**RAI Volume 3, Chapter 2.2.1.2.1, Sixth Set, Number 5:**

**1. RESPONSE****1.1 MACROSCOPIC RESPONSE OF A VORONOI BLOCK MODEL**

Figure 1. Comparison of Stress-Strain Curves Measured in the Laboratory on a Lithophysal Sample and Obtained by Voronoi Block Model Calibration

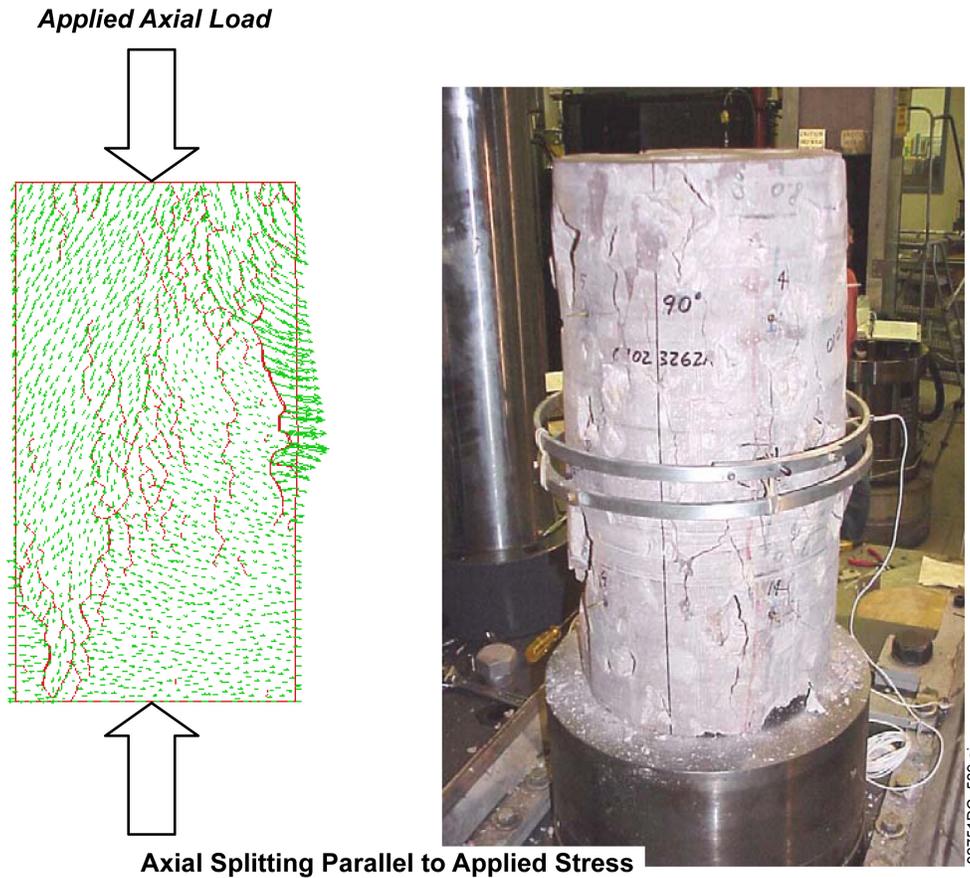
Provide an explanation of how rock blocks at the drift interface maintain cohesion after failure when the modeled stress-strain curve (DOE, 2009, RAI-3, Figure 1-4) indicates a brittle mode of rock failure should occur. Additionally, clarify how blocks in the UDEC-Voronoi model remain in place if the supporting contacts between the blocks have failed.

Basis: DOE concluded the UDEC-Voronoi model shows a more brittle response compared to the stress-strain test on Topopah Spring lower lithophysal tuff (DOE, 2009, RAI-3 and RAI-5). Additionally, the modeled post-peak curves presented in BSC (2004, section 7.6.4) are nearly vertical, and represent a near-brittle mode of deformation (e.g., Jaeger and Cook, 1979). Thus, the near-vertical slope of the post-peak portion of the modeled stress-strain curves suggests that, after failure, the remaining rock strength should be negligible, consistent with a brittle failure mechanism. Additionally, in DOE (2009, RAI-1, Figure 1-3), the UDEC model appears to allow some blocks at the drift wall to remain in place after the supporting contacts between the blocks have failed. This result appears inconsistent with the modeling approach, in which blocks supported by failed contacts should fall from the drift wall.

Even in the post-peak state, Figure 1 demonstrates that the rock within the synthetic model has not completely disintegrated after formation of discrete macro fractures. Although stress can decrease to 50% of the peak stress in the post-fracture state, as shown by the end of the blue line in Figure 1, the material is not perfectly brittle because the post-peak slope of the blue stress-strain curve remains finite. This behavior is consistent with Figure 2, which compares the geometry and cracking of the UDEC Voronoi block model with a test core at the end of an unconfined compression test. Figure 2 shows that, at the end of testing, there is still a large volume of rock that is unfractured for both the Voronoi block model and for the test core. Although Figures 1 and 2 show that the macroscopic response of the core after failure is softening in a brittle manner and losing a significant portion of its apparent (macroscopic) cohesion, large volumes of rock internally maintain their intact cohesion. The term “softening” describes degradation of strength as a function of deformation after the peak-strength of material has been reached (BSC 2004, Section 7.4.1).

The post-failure response of the Voronoi block model is not perfectly brittle because of the presence of unfractured rock mass and because of the frictional resistance to slippage in the failed contacts and macro fracture(s). These features produce a finite softening rate and some residual strength after failure of the core, as shown by the finite slope of the blue curve in Figure 1 after peak stress. Stated differently, the UDEC Voronoi block model under unconfined compression has some small but finite ductility. At any point of the stress-strain curve, even on the softening part, it is necessary to provide additional energy to continue deformation of the sample.
